PRODUCT SERVICE BULLETIN

Safety report bulletin PS 04202012

***RESERVE LOWER STEERING LINES
AND
RESERVE TOGGLES***

APRIL 20, 2012

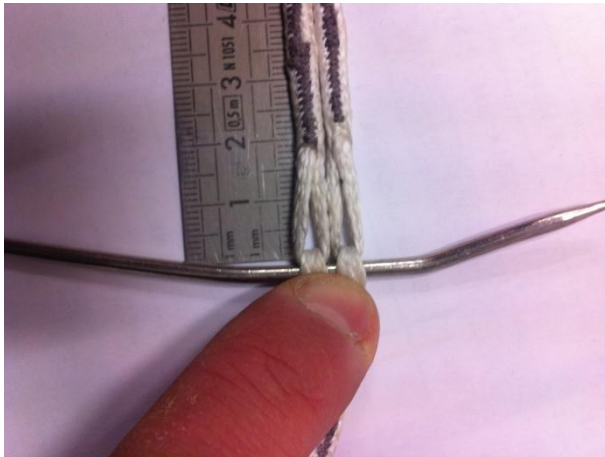
Background: Right reserve toggle locked after a cutaway procedure generating 2 rapid turns.
April 13, 2012 (Gap, France)

1. Bartack sewing on the right lower steering line is too close to the brake set loop (5mm or 3/16" less than the left one)
2. Toggles nozzle are too soft, implying a nozzle narrowing.
